Detailed Site Plan Alternative Compliance Spirit of God Deliverance Church

**DSP-21012
AC-21020**

SUBJECT: Detailed Site Plan DSP-21012
Type 2 Tree Conservation Plan TCP2-043-2021
Alternative Compliance AC-21020
Spirit of God Deliverance Church

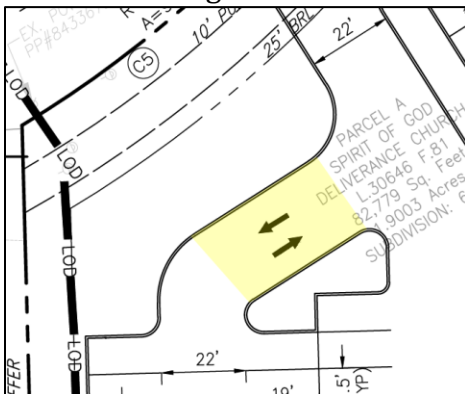
PARKING REQUIREMENT		
USE OF MEASUREMENT	# OF SPACES	REFERENCE
1 PER 4 SEATS IN MAIN AUDITORIUM (500 SEATS PROPOSED)	125	(MUNICODE SEC. 27-568)
1 PER 4 SEATS IN OTHER ROOMS OCCUPIED AT THE SAME TIME AS MAIN AUDITORIUM	0	(MUNICODE SEC. 27-568)
TOTAL PARKING REQUIRED	125	
ADA PARKING PROVIDED/ INCLUDED IN TOTAL PARKING	5	4 CAR SPACES, 1 VAN SPACE
TOTAL PARKING PROVIDED	126

- A church falls under the greater/general use category of “Institutional/Educational”, which is required to provide Loading at a rate of 1 Loading Space for every 10,000 to 100,000 SF of GFA, per Sec. 27-582(a) in Part 11 of the Ordinance for “Hospitals or other Institutions”. Please, therefore, include one (1) loading space in your parking schedule and on your site plan.
- Provide missing drive aisle width on plan highlighted in the excerpt below:

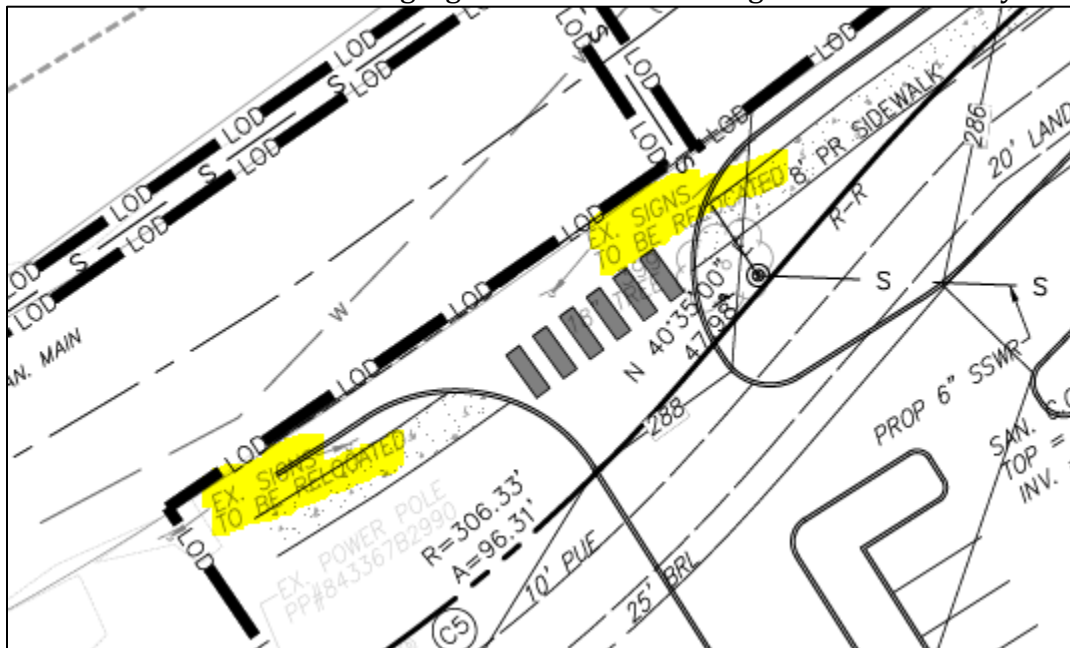
- Identify the fence on the plan near, at or along the southern property line, with a callout showing if it is existing or proposed and including the height and fence type. If the fence

is “Proposed”, include a fence detail on the detail sheet and reference it in the callout, as “See Detail ___”.

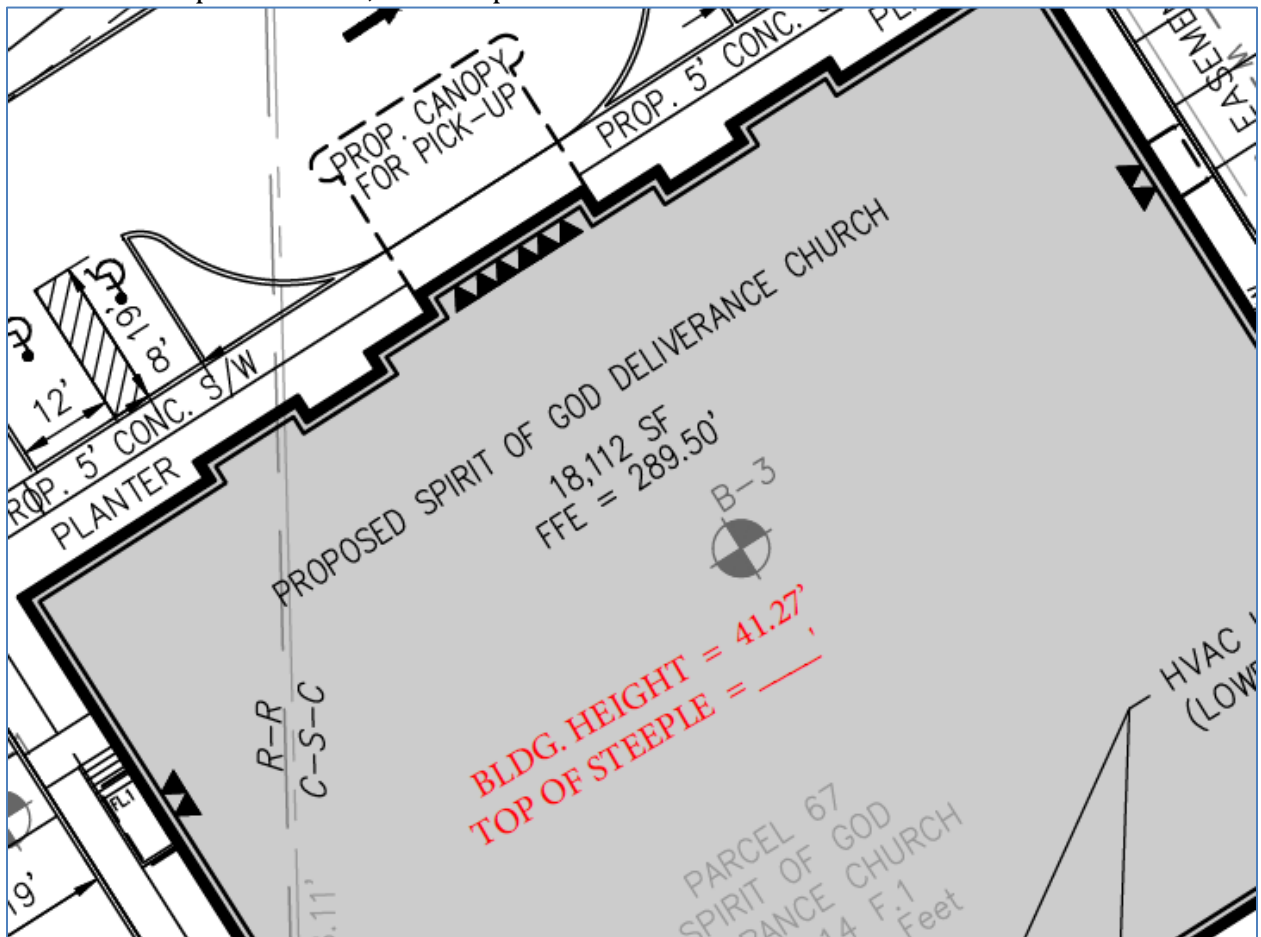
7. For the Canopy and for the Dumpster, the callout on the plan should include “See Detail ___”. In general, all proposed structures should call out “See Detail X” and those details should, of course, be provided on the detail sheet(s) of your DSP.
8. Mark the HC Van space on the plan as “VAN” and add the width of the striped HC access aisles to the plan as well.
9. Make the reference to existing signs to be relocated larger and more easily read:

10. Show the new proposed location of the sign(s) on the plan. If not included with this approval, applicant will be required to file a revision to the DSP to add them before any sign permits will be approved.
11. Provide sign table that includes your building and ground signs with calculations demonstrating conformance to Part 12 of the Zoning Ordinance. Again, any sign (building or ground) not approved with this DSP will need to be added through a DSP revision before sign permits will be approved by M-NCPPC.
